DESCRIPTIVE REPORT (HYDROGRAPHIC)

Type of Survey WIRE DRAG
SP-AMC-6-RU/HE-71
Field No. RH-10-2-71WD Office No. F.E.No.2-1971
Wire Drag

DESCRIPTIVE REPORT
TO ACCOMPANY
WIRE DRAG FIELD NO. RH-10-2-71
PROJECT SP-AMC-6-RU/HE-71
WINYAH BAY ENTRANCE AND JACKSONVILLE BEACH
1971
LCDR MERRITT N. WALTER
NOAA SHIPS RUDE & HECK

VERIFICATION BRANCH
ADDENDUM
To Accompany

Chart - 1238

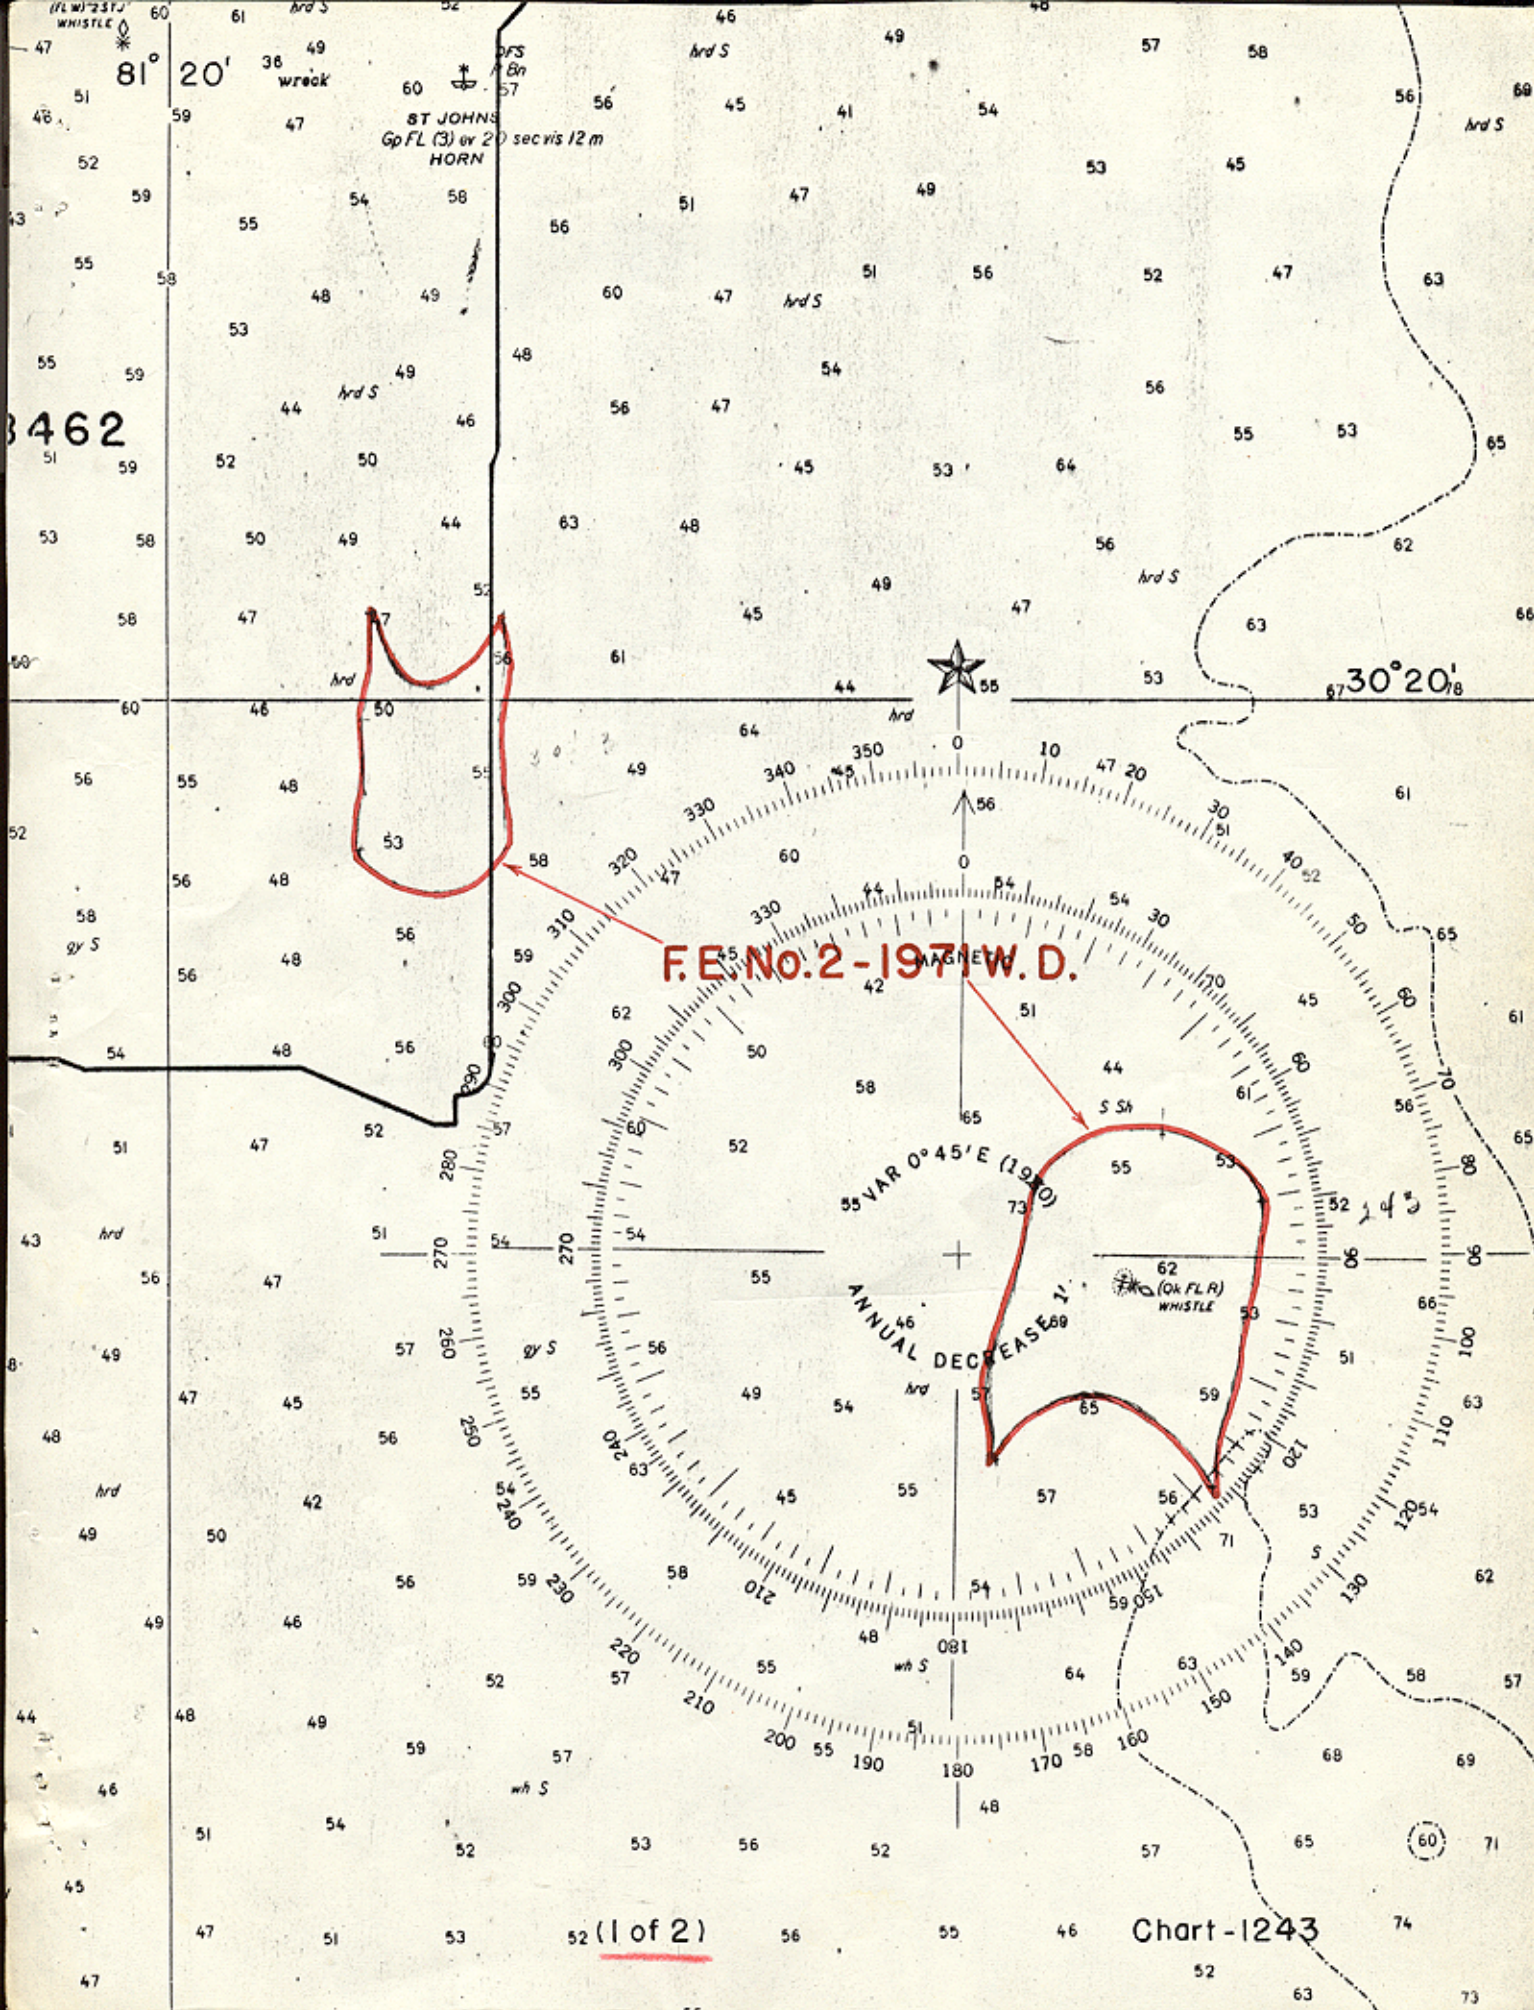
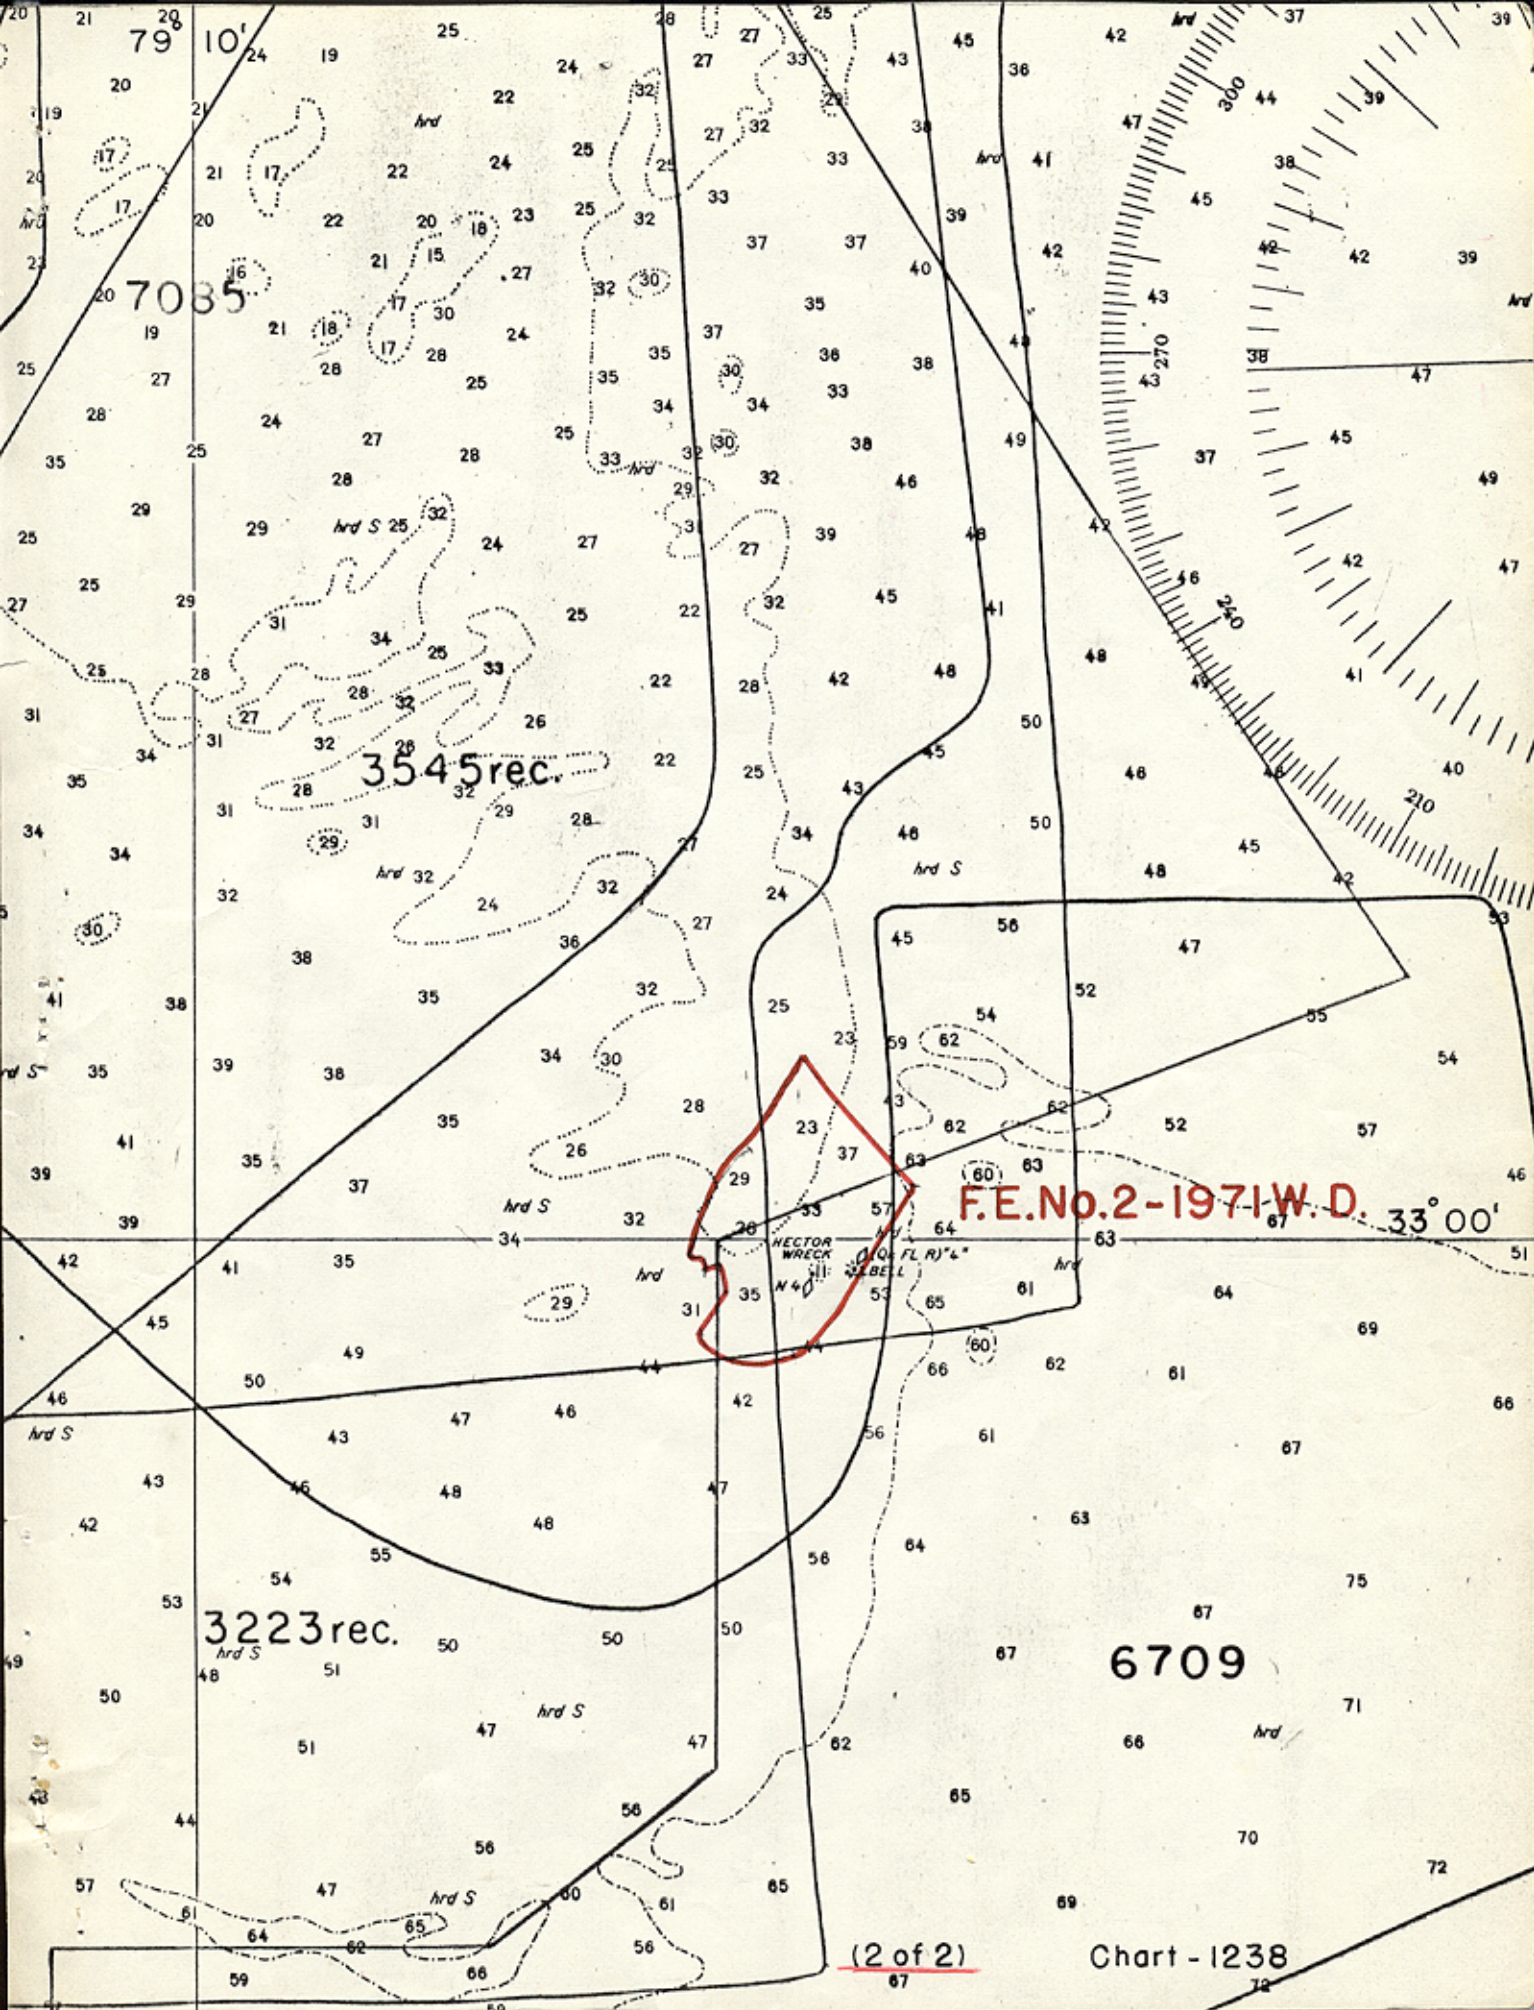
Recommend the wreck now be charted at 33° 00' 04.0" N 79° 06' 08.5" W and shown as cleared by wire drag to 10 ft MLW.

The wreck is presently charted as cleared to an effective depth of 9 ft. (Chart 11531 13 th. ed. Mar. 22/80).
It should be retained as presently charted.

Wire drag on HECTOR WRECK was plotted on sheet designated 1 of 3. The item was hung at an effective depth of 21 feet and cleared at 9 feet. A shoal sounding of 13 feet was obtained with the drag tester with diver assistance. CONCUR

The drag results appear to be adequate except the effective clearance of the 13 foot sounding should have been deeper. CONCUR
